Road Safety Audit Stage 1

Derby Road

Report Title Derby Road, Eastleigh Road Safety Audit Stage 1

Document Ref PBA/23/131.0009/1/MM	Prepared by: (Name)	Checked by: (Name)	Approved by (Signature)	Date Approved
Original	Martin Morris	Bryan Shawyer		17 th May 2023
A	Martin Morris	Bryan Shawyer		28 th June 2023
Designers Response				
Authority Response

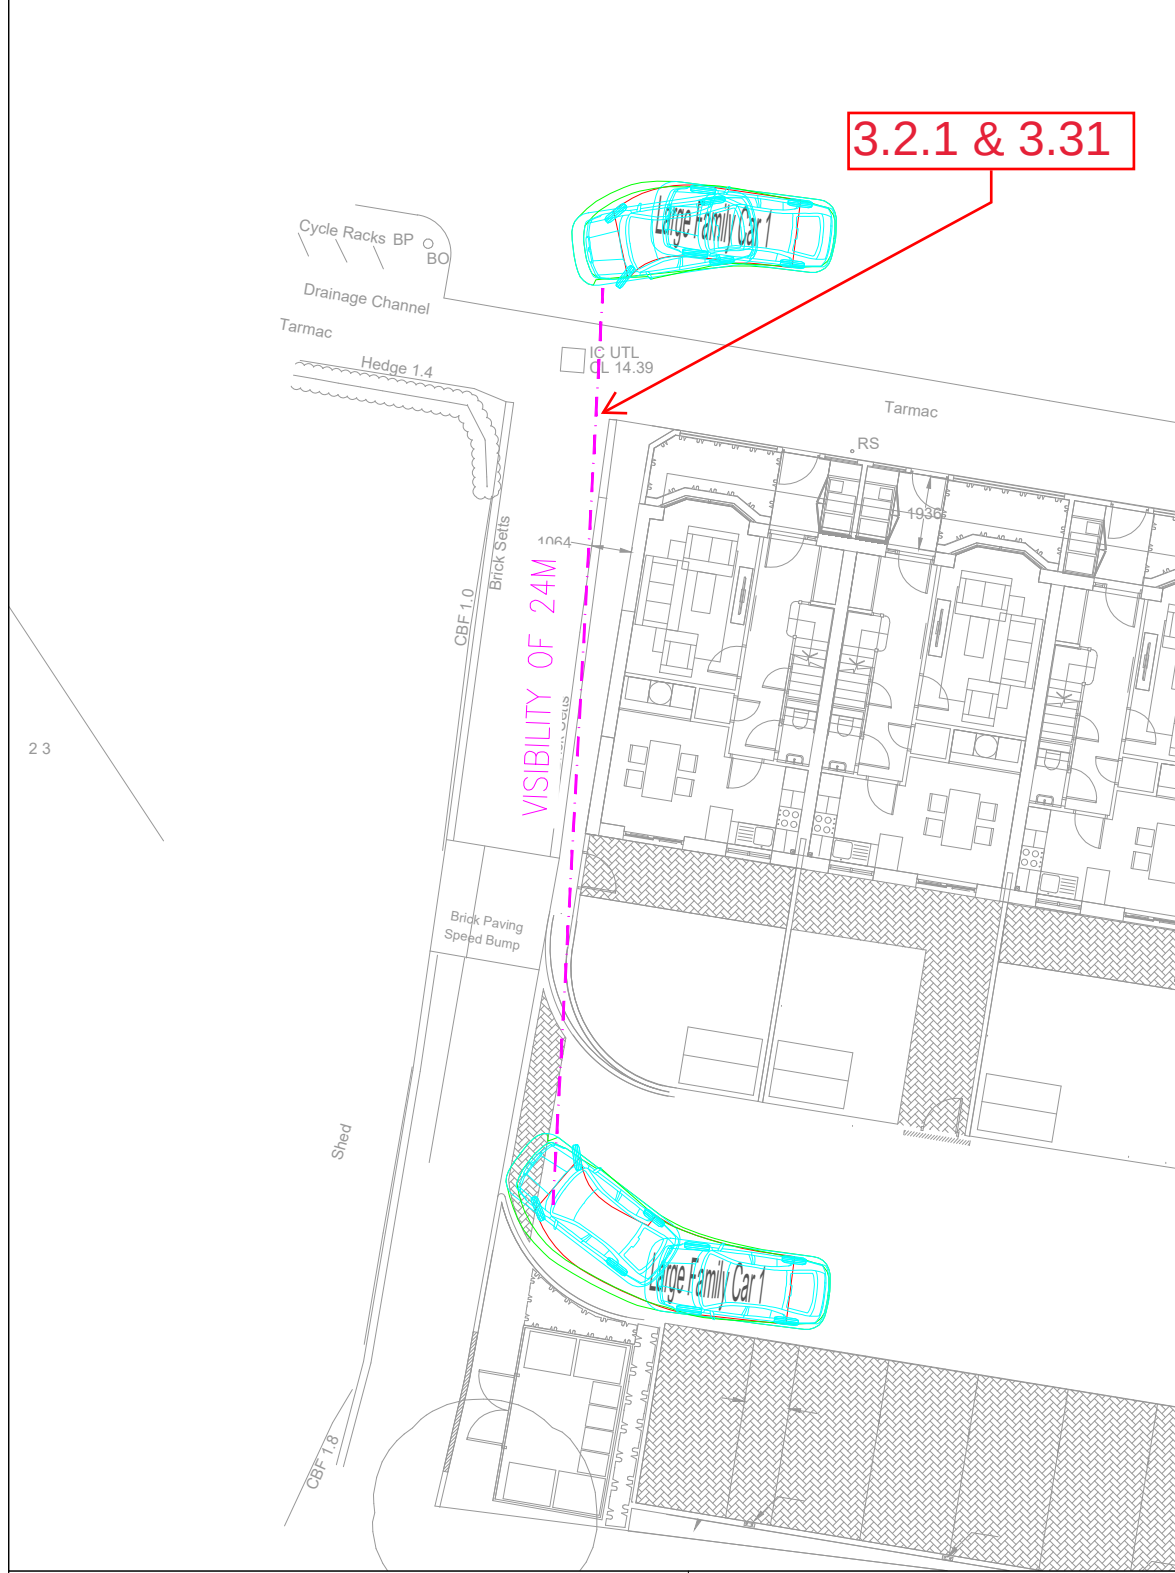
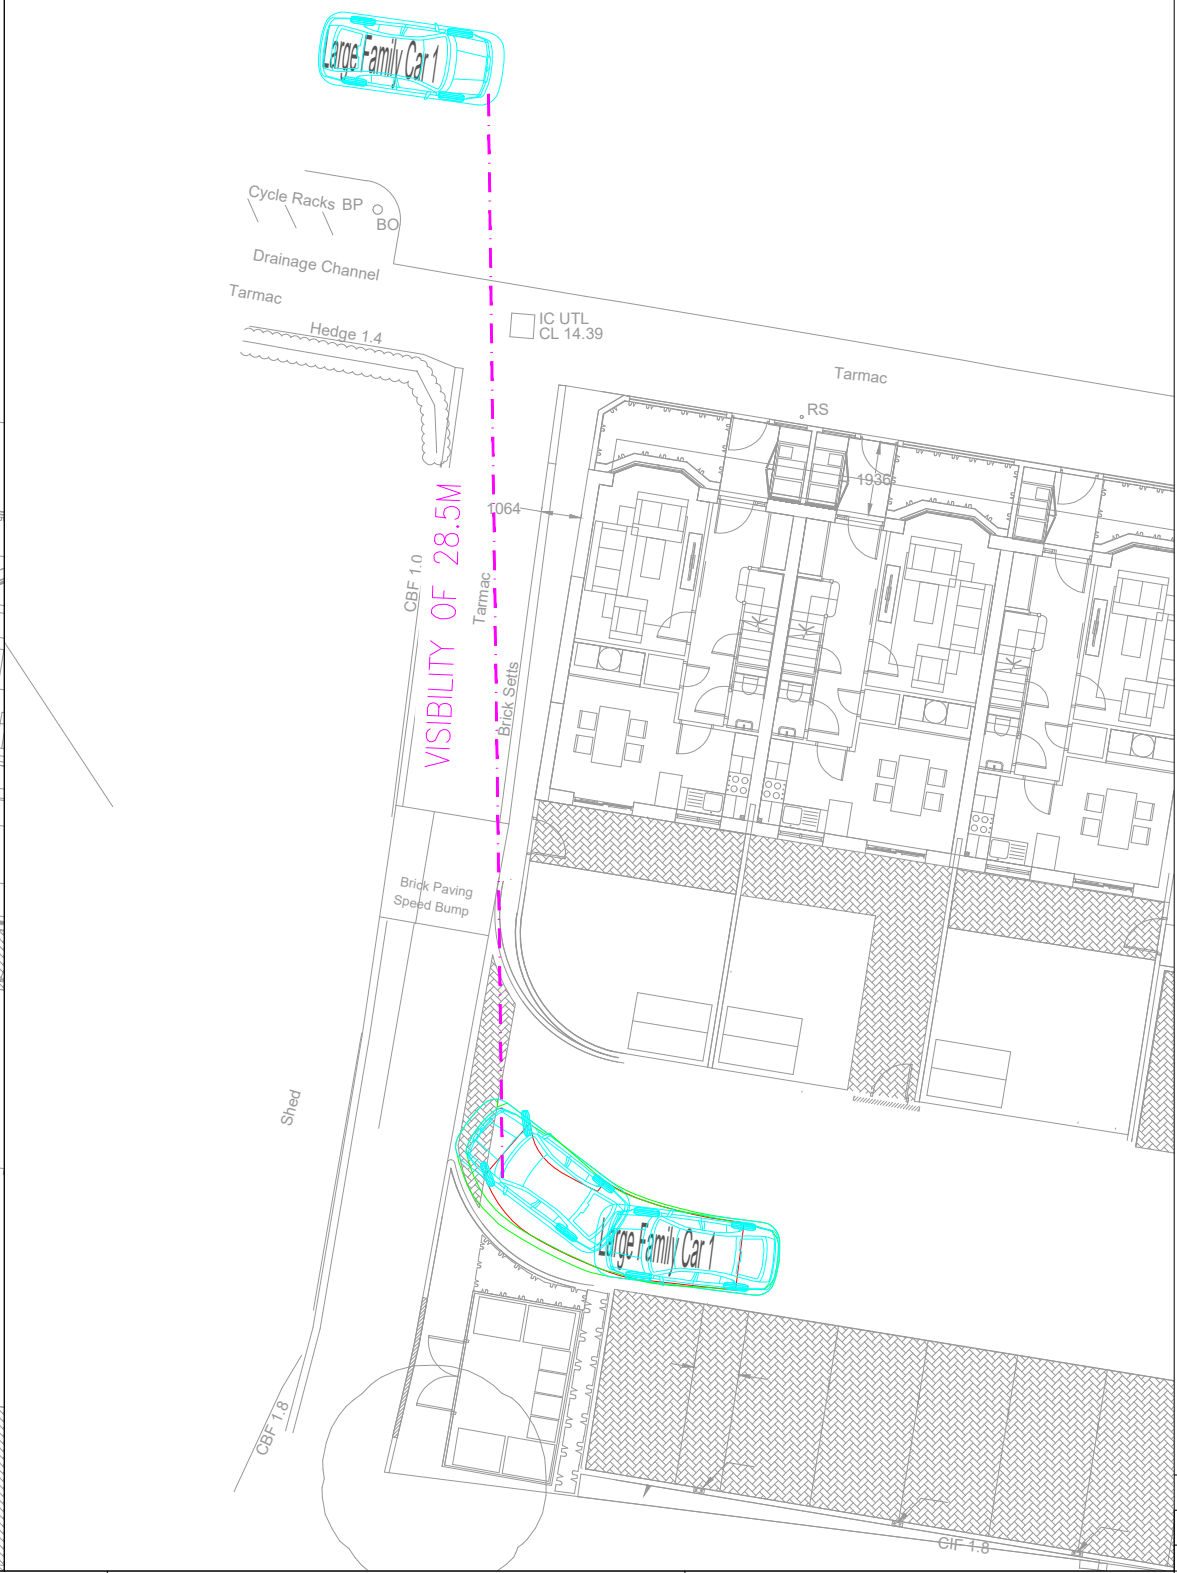
Location: Access Road junction with Derby Road.

Summary: Lack of visibility could lead to side impact collisions or rear end shunts.

No visibility splays have been provided for assessment at the Access Road junction with Derby Road, where there is concern that parking and the bus stop may restrict visibility – see figures 1&2 overleaf, however, it is recognised that this is an existing situation. Insufficient visibility could lead to side impact collisions or rear end shunt collisions.

It is recommended that the parking bay to the east of the access should be reduced in length to aid visibility.

3.3.1 PROBLEM Location: Access Road junction with Derby Road. Summary: Lack of visibility could lead to side impact collisions or rear end shunts. No visibility splays have been provided for assessment at the Access Road junction with Derby Road, where there is concern that parking and the bus stop may restrict visibility – see figures 1&2, if, however, it is recognised that this is an existing situation. Insufficient visibility could lead to side impact collisions or rear end shunt collisions.	It is recommended that the parking bay to the east of the access should be reduced in length to aid visibility.	No visibility splays were provided at the access of the Service Road with Derby Road as this junction is an existing vehicle crossover which does not have a record of accidents despite both the on-street parking and bus stop already being in situ. Based on the low traffic generation of the proposals it is considered that this would not result in a severe highway safety concern in accordance with the NPPF. Furthermore, Manual for Streets and Manual for Streets 2 both state that parking is considered a temporary obstacle which should not cause safety concerns in practice as vehicles would tend to nudge out until they have the clear visibility. The build out to the west of the access further enforces this point and ensures vehicles would not be waiting in the highway.
